**ANNEXURE E16: CONFIRMATION OF ALL SERVICES  
(WATER, ELECTRICITY, SEWAGE, SOLID WASTE  
MANAGEMENT)**

**ENGINEERING AND PLANNING SERVICES: SOLID WASTE MANAGEMENT: CONFIRMATION OF CAPACITY  
SOLID WASTE COLLECTIONS AND DISPOSAL: PATERNOSTER FARM 1259 AND ERVEN 583, 1613, 1751,  
1752 AND 1753: PROPOSED TOURIST COMPLEX.**

**ENGINEERING AND PLANNING SERVICES: WATER AND SANITATION:  
CONFIRMATION OF CAPACITY BULK WATER AND SEWER: PATERNOSTER FARM 1259  
AND ERVEN 583,1613,1751,1752 AND 1753 : PROPOSED TOURIST COMPLEX**

**PROPOSED MIXED-USE DEVELOPMENT ON ERVEN 1605-1610, 1613, 1751-1753 & FARM 1259, PATERNOSTER: CAPACITY ANALYSIS OF THE BULK WATER AND SEWER SERVICES**

Q ä ^ í Á F  
Úí [ ] [ ^ á Á ^ c ^ [ ] { ^ } c  
Óí [ ] á l q ^ ^ Á Á í [ ] l í c á  
Ócā cā \* Á æ'í Á ^ c í

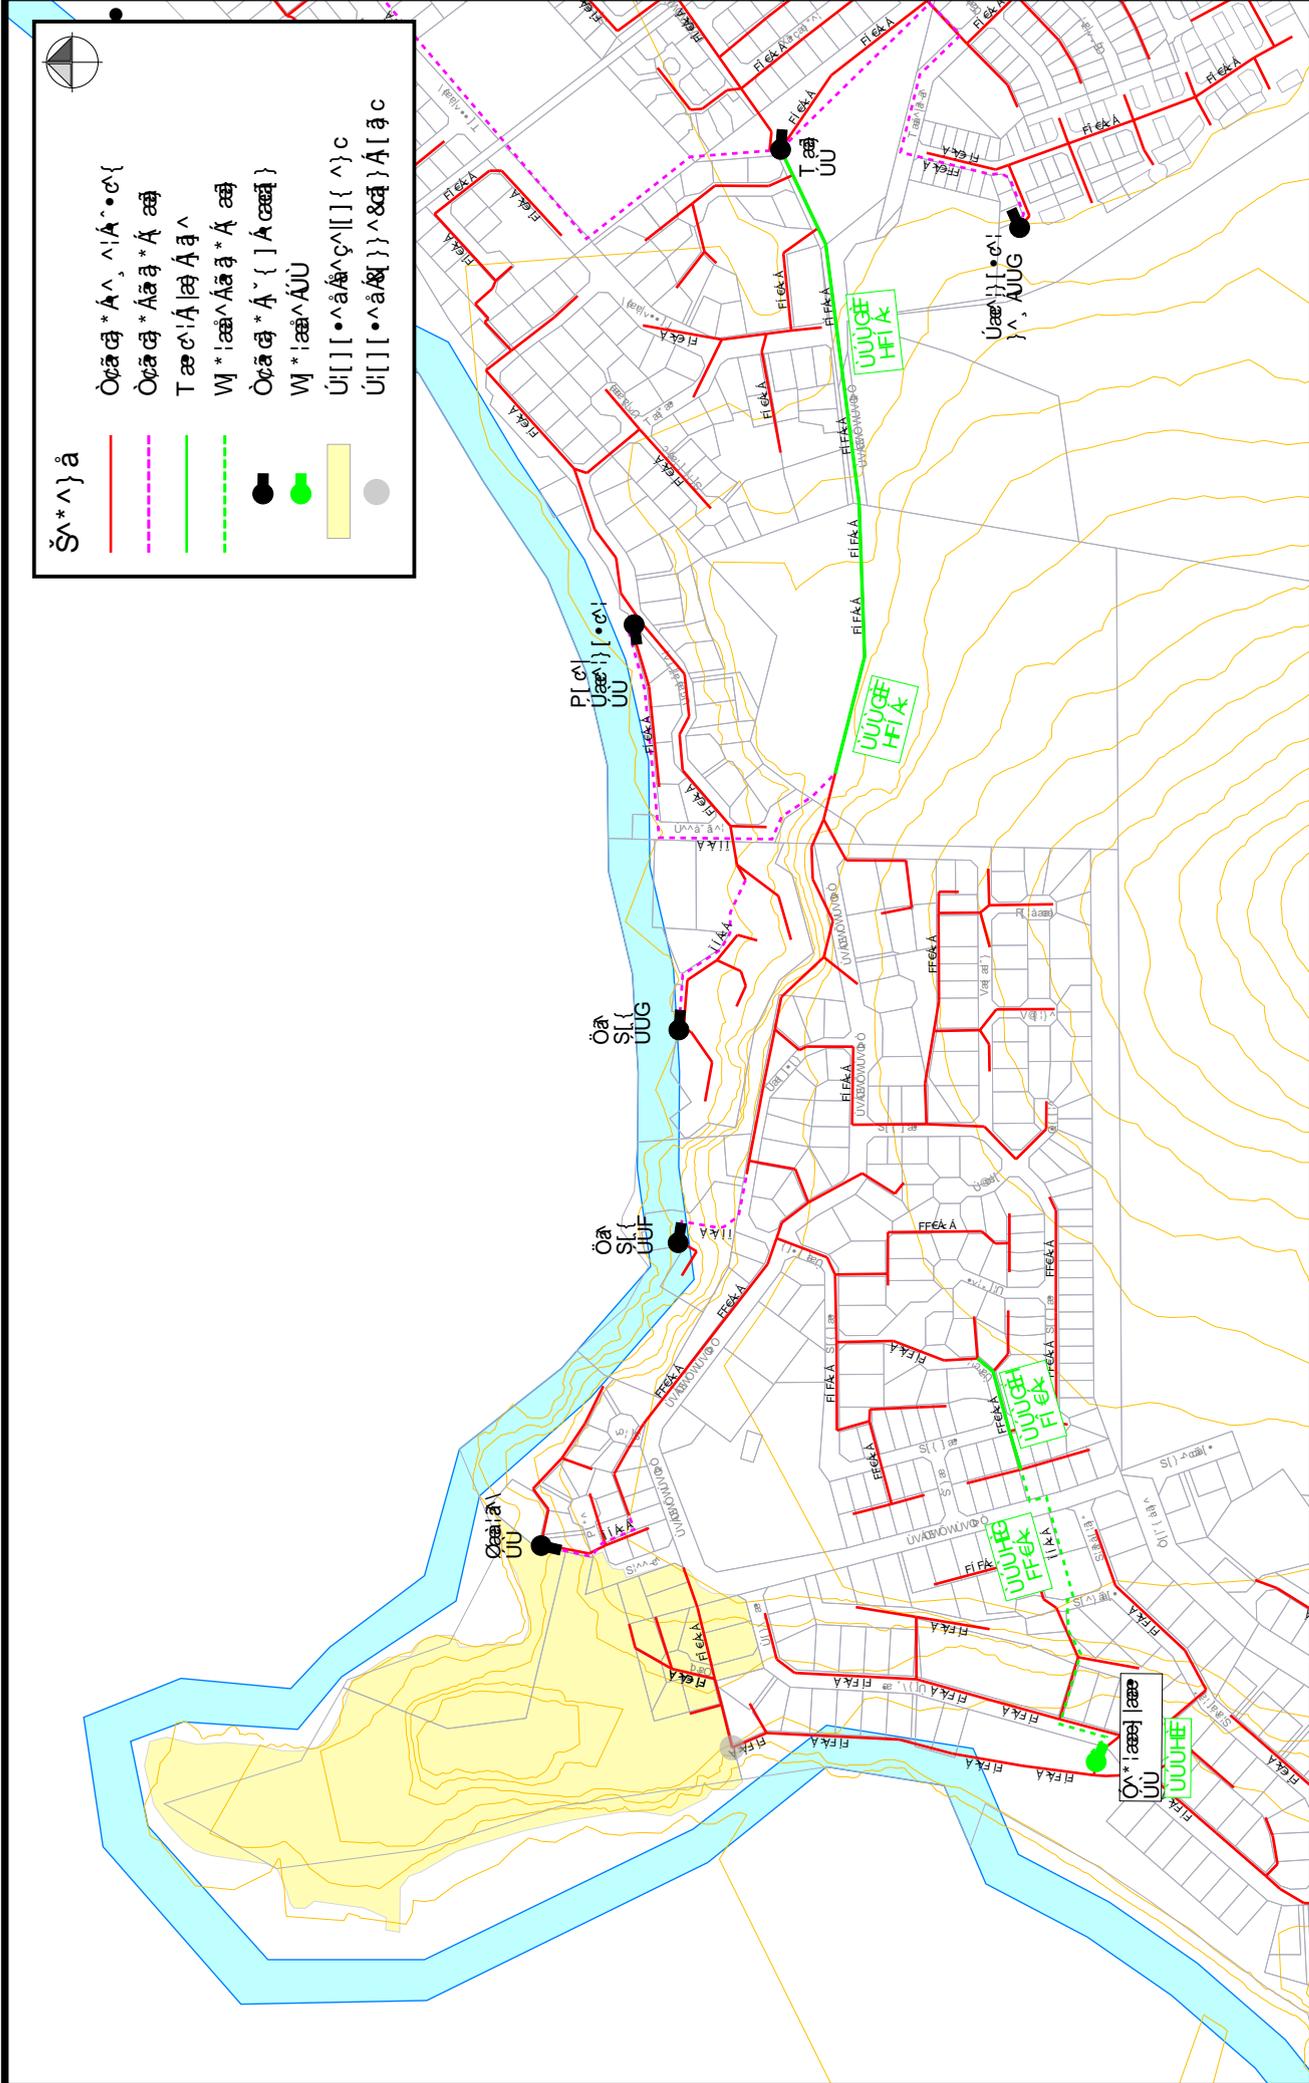
The water master plan indicated that the proposed development should be accommodated in the existing Paternoster reservoir zone. The connection to the existing water system should be made to the existing 110 mm Ø pipe in Bietou Street, as shown on Figure 1 attached.

The hydraulic water analysis however indicated that the existing network can only provide a maximum fire flow of 20 L/s @ 10 m at the proposed connection point. In order to provide fire flow in excess of the 25 L/s @ 10m fire flow criteria, the Paternoster water reticulation network should be upgraded as per Figure 1 attached.

Alternatively, on-site storage for fire flow conditions should be provided.
